Access Compliance Report

Public Rights-of-Way

Intersection ID: 45988	Main Street: CHESTERBROOK_LN	Cross Street: NORTH_VALLEY_CT	Location: SW
ADA ID: D8973C6B4E73	Ramp Type: PerpDiag	Initial Pass/Fail: Fail	Overall Compliance: No
Severity Score: 30			
Codes/Mitigation Info/Possible Solution		Field Measurements/Component Compliance

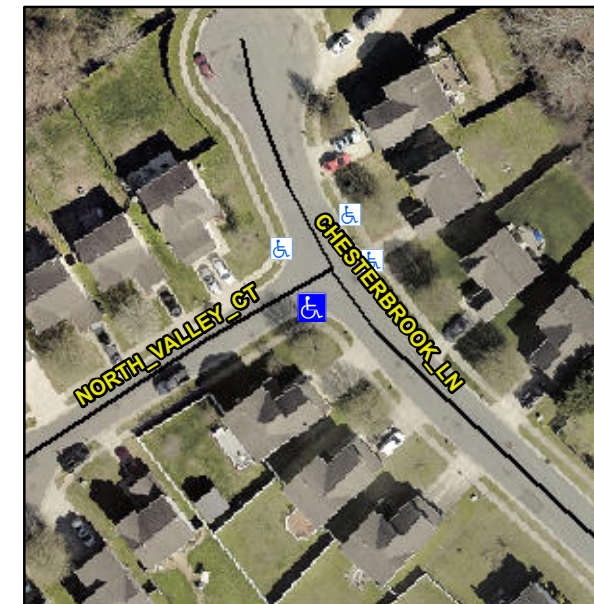
Not Found, R304.5.1, R304.5.3

Compliance	Description	Data	Compliance	Description	Data
N/A	Ramp Length (in)	50.0	Yes	Ramp Slope (%)	8.0
No	Ramp Width (in)	35.0	No	Ramp XSlope (%)	5.3
N/A	Flare Type LT	N/A	N/A	Flare Type RT	N/A
N/A	Flare Slope LT (%)	N/A	N/A	Flare Slope RT (%)	N/A
N/A	Flare Traversable LT?	N/A	N/A	Flare Traversable RT?	N/A
N/A	Landing Length (in)	N/A	N/A	DWS Provided?	N/A
N/A	Landing Width (in)	N/A	N/A	DWS Contrast?	N/A
N/A	Landing Slope (%)	N/A	N/A	DWS Length (in)	N/A
N/A	Landing X Slope (%)	N/A	N/A	DWS Full Width?	N/A
N/A	Landing Curb? (Y/N)	N/A	N/A	DWS Offset (in)	N/A
N/A	Shared Landing?	N/A			
N/A	Gutter Ponding?	N/A	N/A	Gutter Slope (%)	N/A
N/A	Gutter Lip Ht (in)	N/A	N/A	Gutter X Slope (%)	N/A
N/A	Painted X Walk1?	No	N/A	Painted X Walk2?	No
	X Walk 1 Direction	To E		X Walk 2 Direction	To N
N/A	X Walk 1 Width (in)	N/A	N/A	X Walk 2 Width (in)	N/A
	X Walk 1 Slope (%)	2.5		X Walk 2 Slope (%)	2.3
	X Walk 1 X Slope (%)	2.6		X Walk 2 X Slope (%)	1.4

N/A	Ramp inside XWalk1?	N/A	N/A	Ramp inside XWalk2?	N/A
	Road Slope (%)	2.6	N/A	Clear Space?	N/A
	Road X Slope (%)	1.7	N/A	Clear Space to XWalk (in)	N/A
N/A	Any Obstructions?	N/A	N/A	Storm Grate/Utility Hazard?	N/A
	Obstruction Type			Storm Grate/Utility Type	
		N/A			N/A
		Yes		Surface Condition? (G/P)	Good

Remove & Replace Curb Ramp With Two New Directional Ramps or Equivalent.
